WAT PRATHAT DOI SUTHEP
BUDDHIST TEMPLE OF NEW MEXICO
EPC SITE PLAN MAJOR AMENDMENT
DFT SIGN OFF

EPC MAJOR AMENDMENT DFT SIGN OFF DOCUMENT

Project # PR-2022-007851
SI-2022-02075 - Site Plan- Major Amendment

RE: PR-2022-007851, SI-2022-02075-Buddhist Temple, Site Plan – EPC Major Amendment

PROJECT NUMBER:
20_1611.03
CAD DWG FILE:
DWL-NM_APS_OSUNA
DRAWN BY:
S.S.
CHECKED BY:
W. EASTMAN
SHEET TITLE:
PARTIAL EXTERIOR ELEVATIONS
SECTIONS AND DETAILS

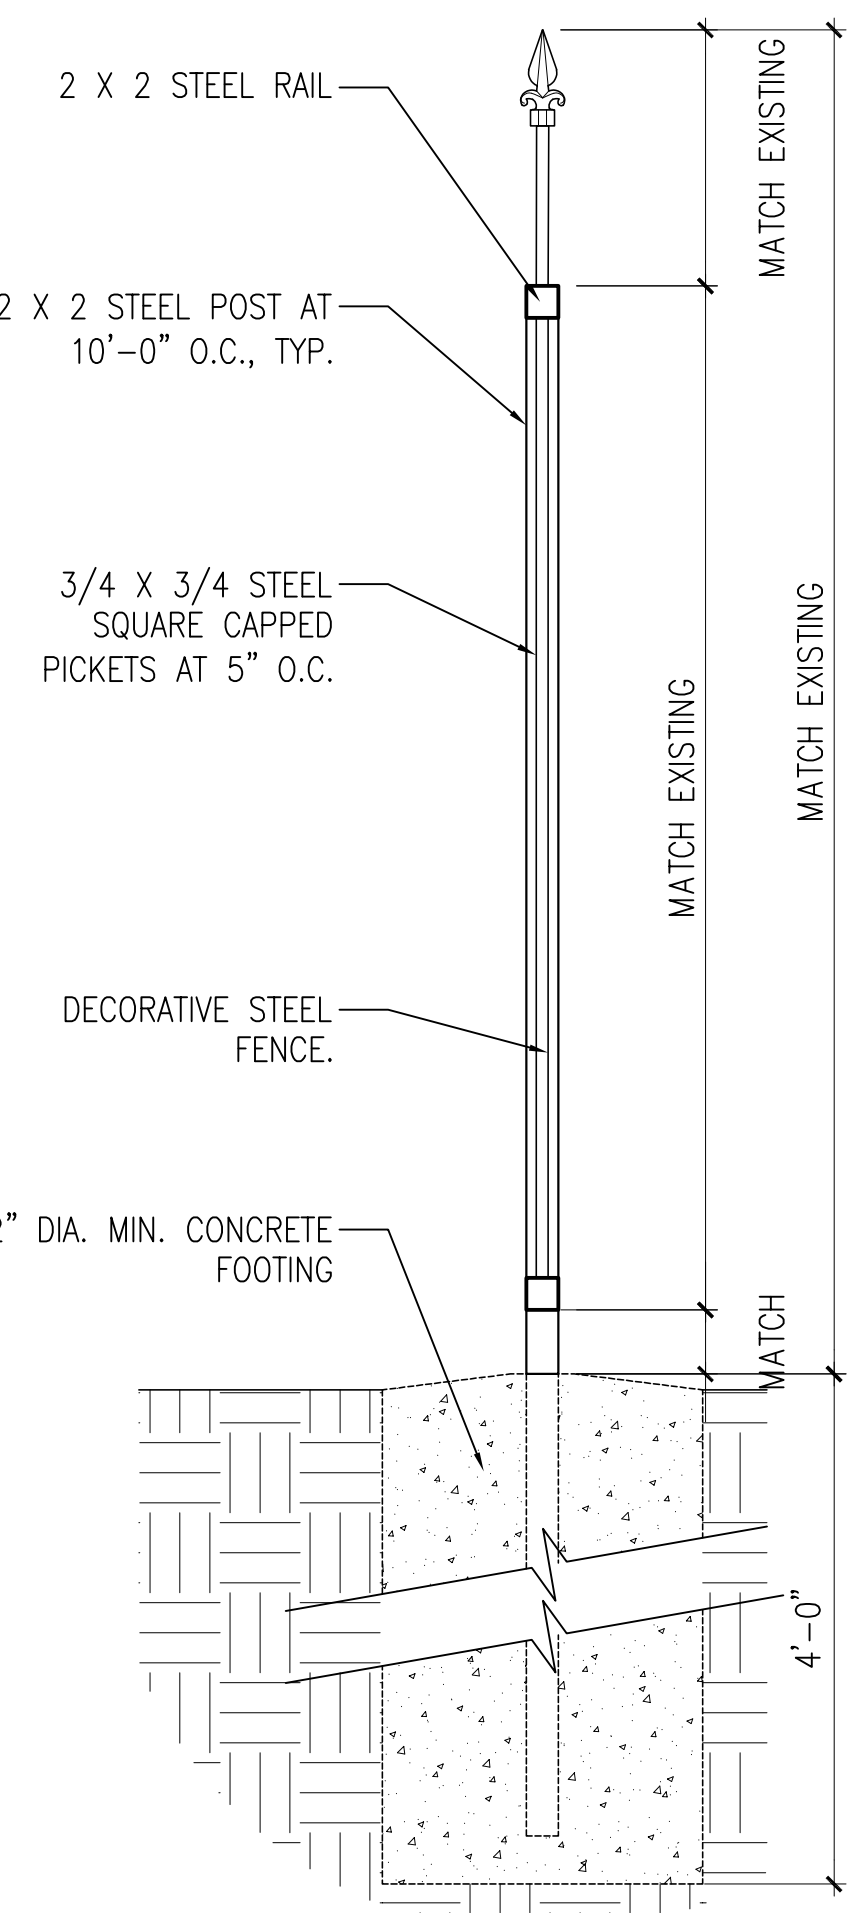
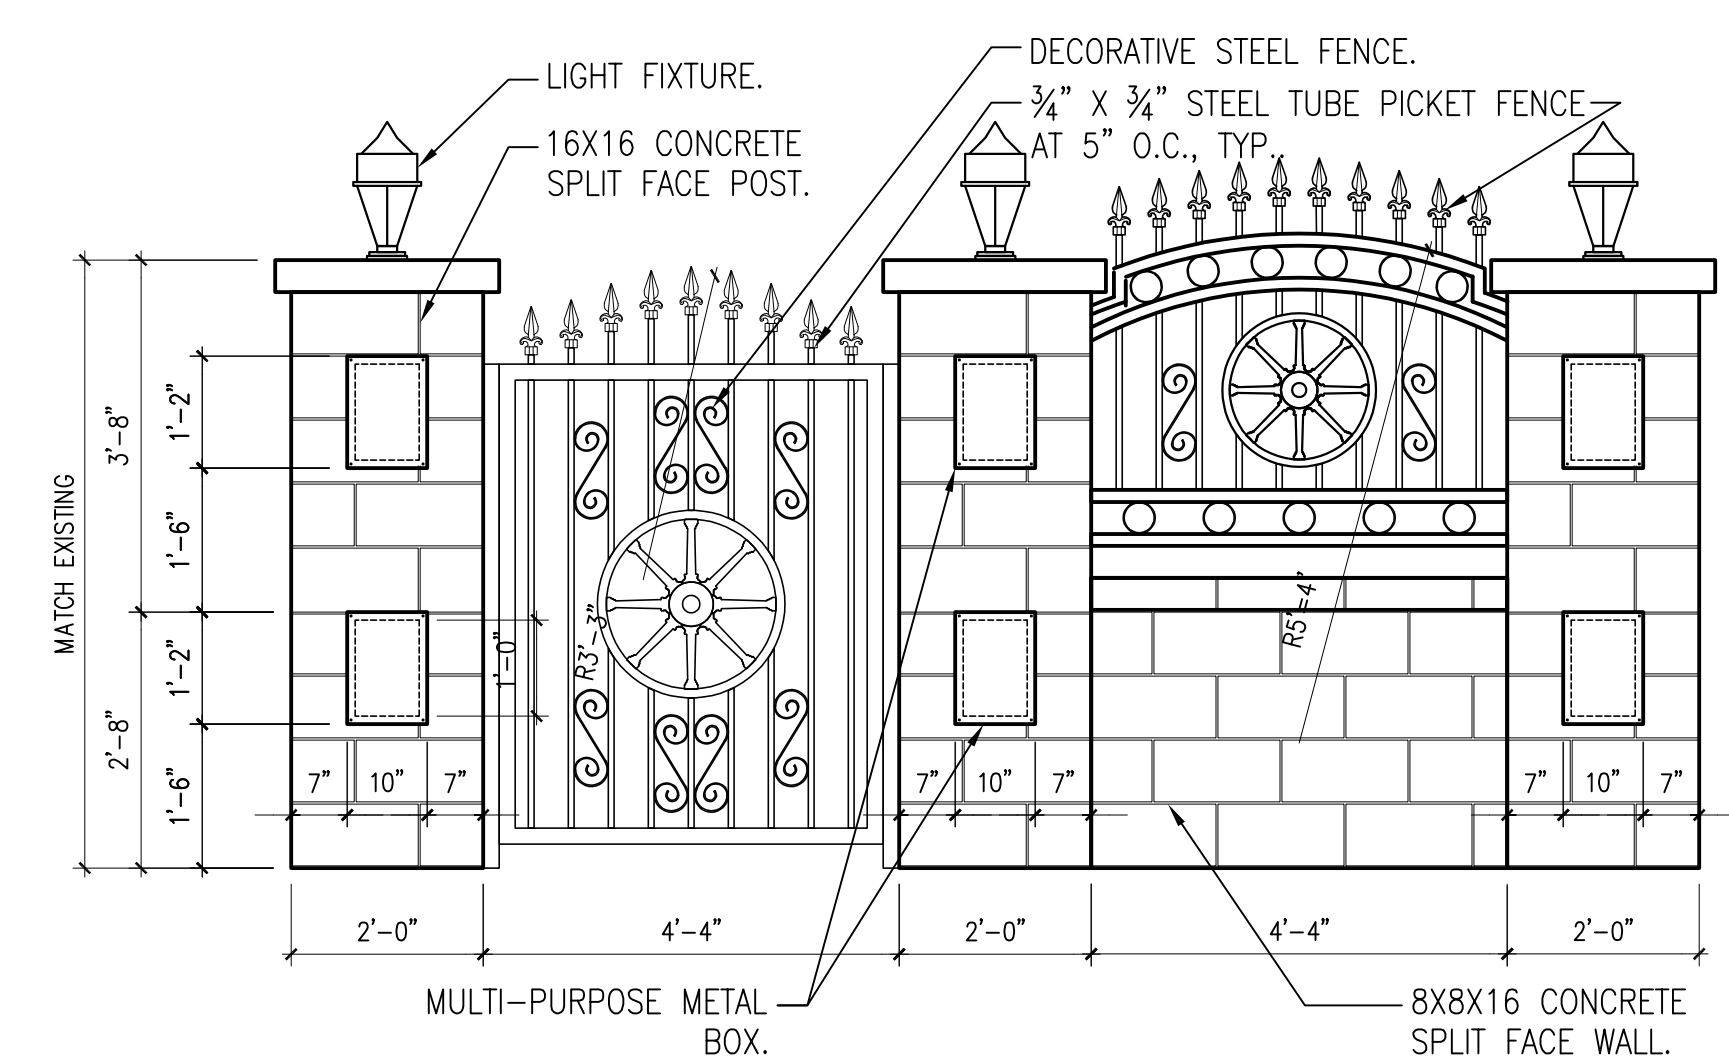
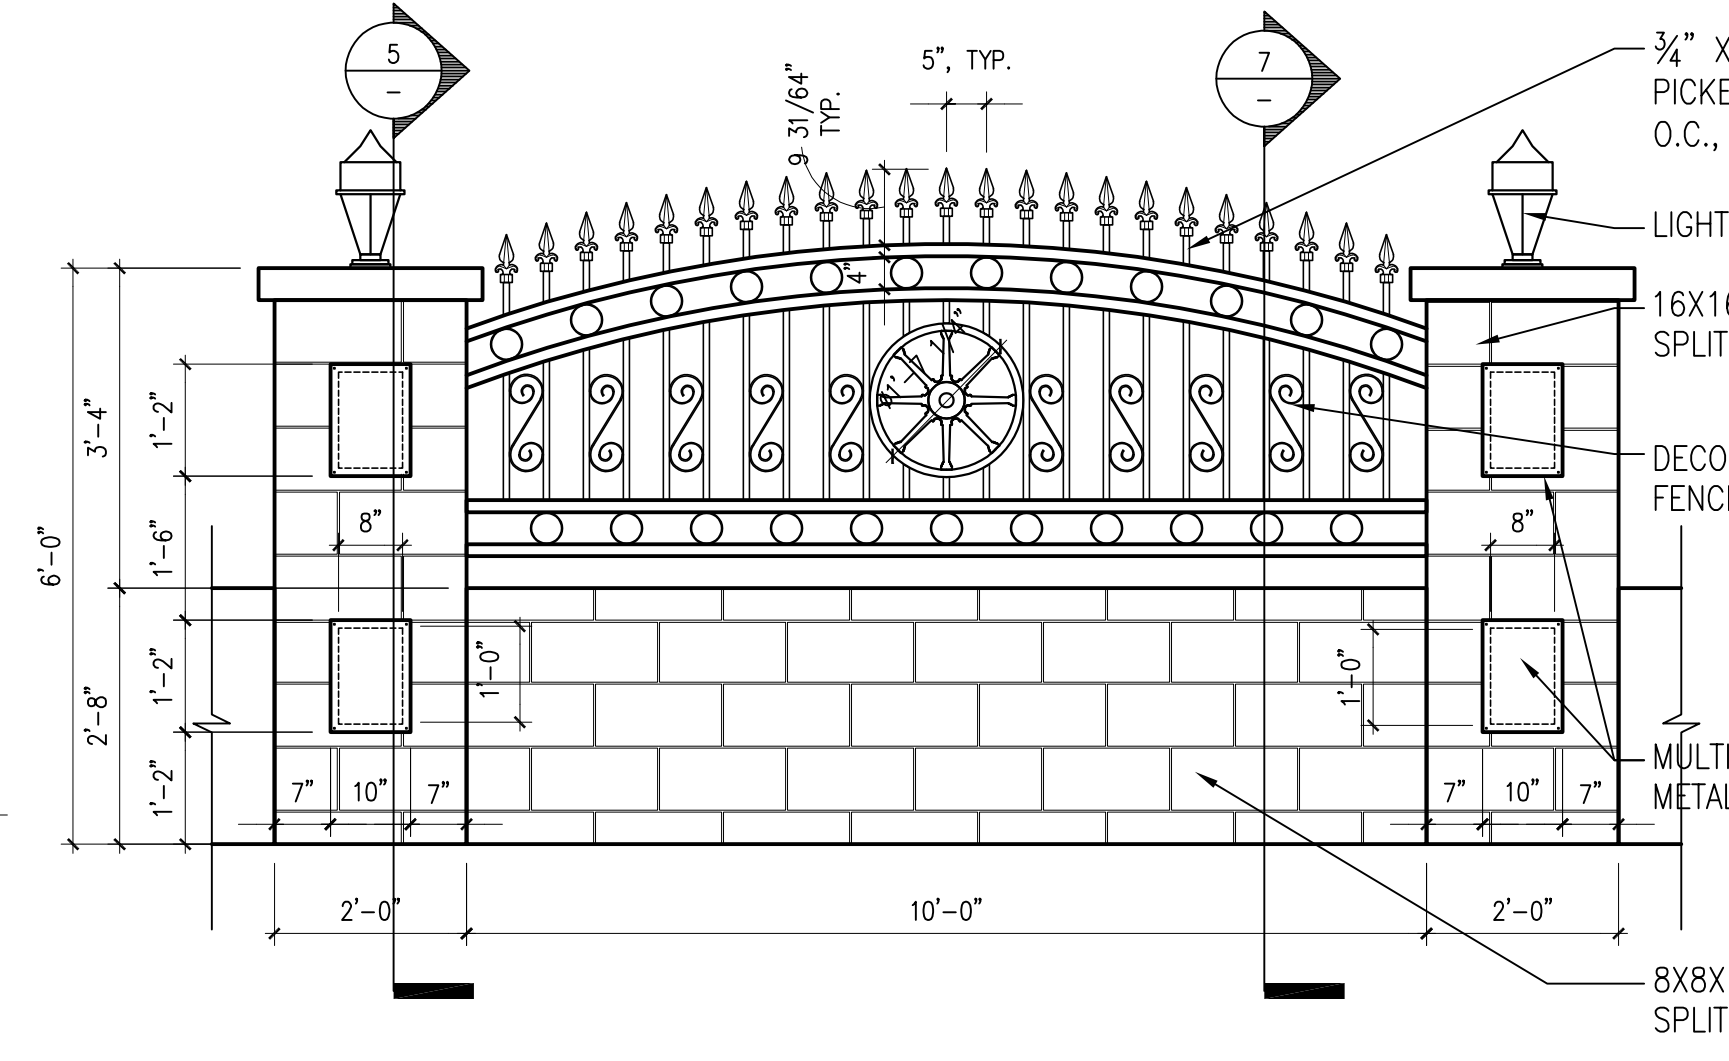
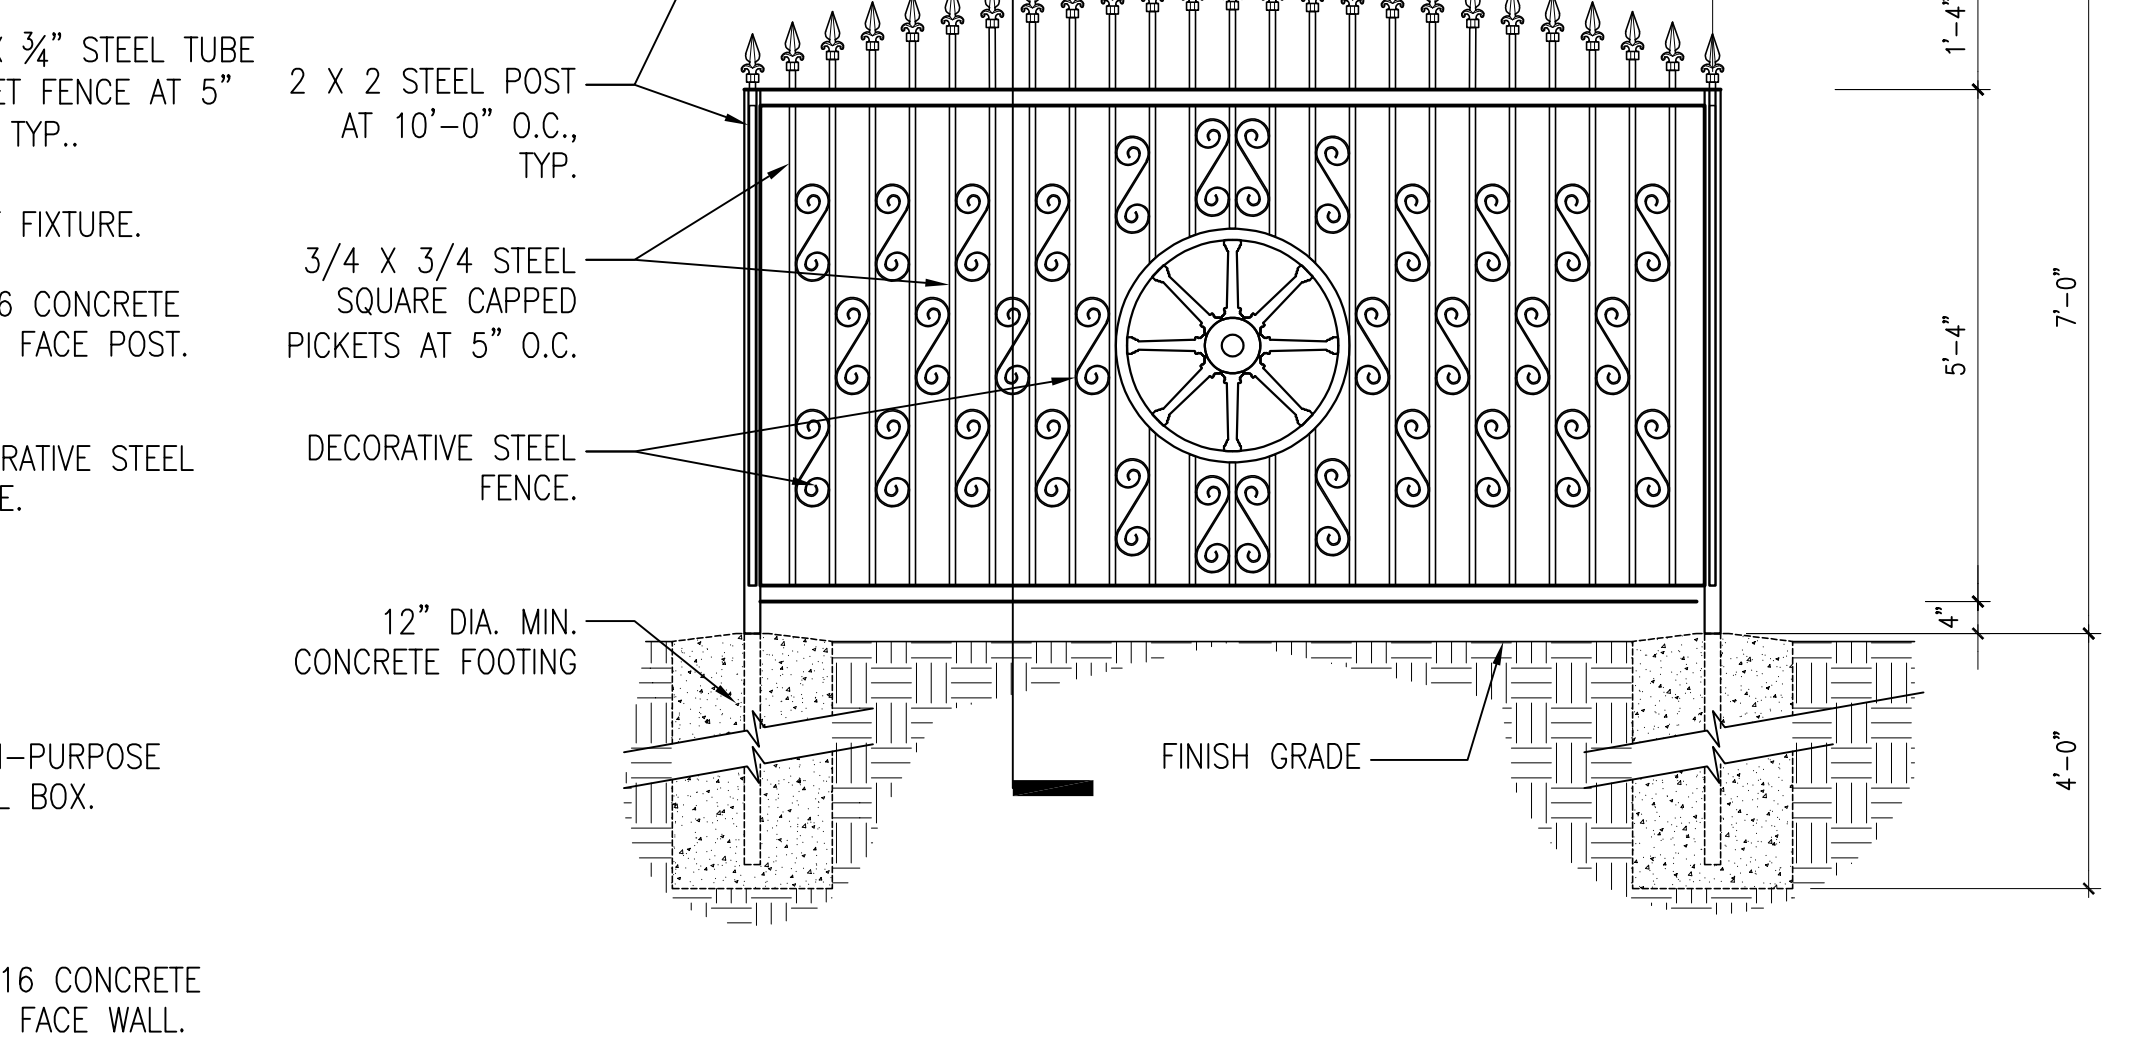
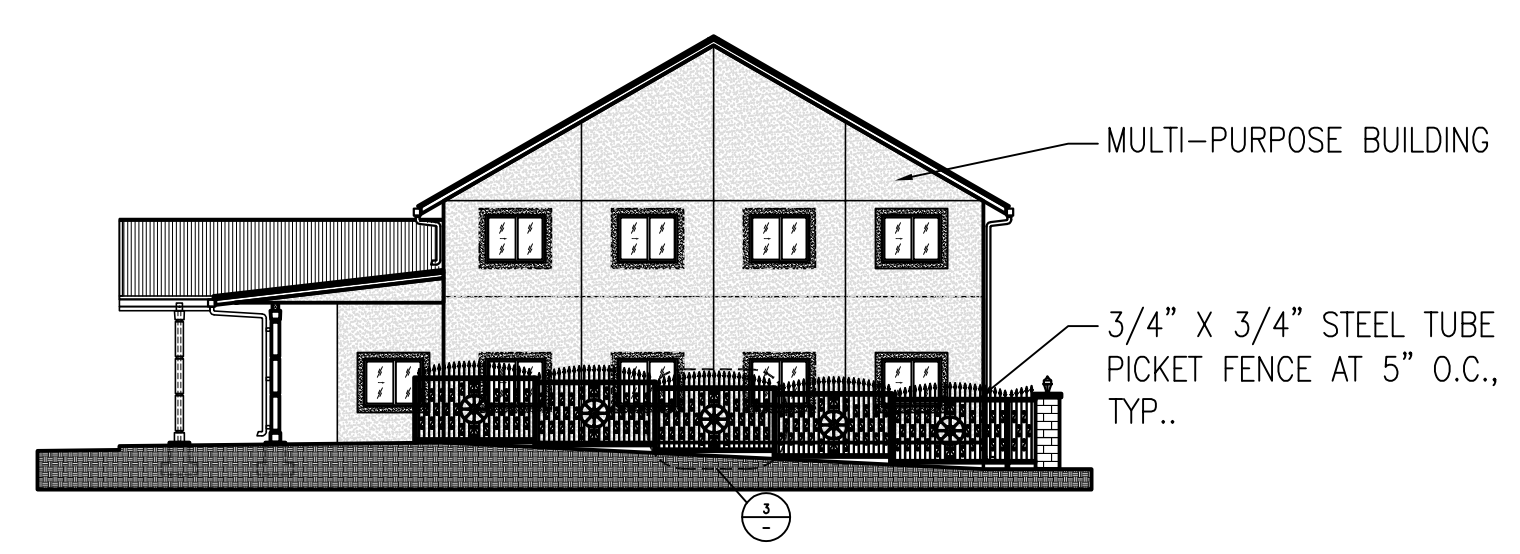
4. Site Plan: Site Plan must show all required dimensions including dimensions between light fixtures.
5. Wall/Fence height shall be subject to IDO standards unless a variance is obtained.

3. Condition has been met.
4. Condition has been met.
5. A variance for the 8-foot wall must be obtained pursuant to IDO 6-6(O) VARIANCE – ZHE. The existing wall along Zuni Rd. in the controlling Site Development Plan was constructed prior to the IDO effective date in 2018. At that time, 8-foot walls were allowed and there were no height limitations for walls in non-residential zones (see Zoning Ordinance in effect prior to 2018). If the applicant wishes to develop an 8-foot wall that matches the existing wall, a variance must be obtained to meet maximum wall height standards in IDO 5-7 before construction.

DWL Architects, Agent for Wat Prathat Doi Suthep Buddhist Temple of New Mexico, has satisfied Conditions for NOD dated December 15, 2022 (PR-2022-007851, SI-2022-02075) Site Plan EPC, Major Amendment. A variance for the proposed wall along Louisiana Blvd. must be obtained before construction.
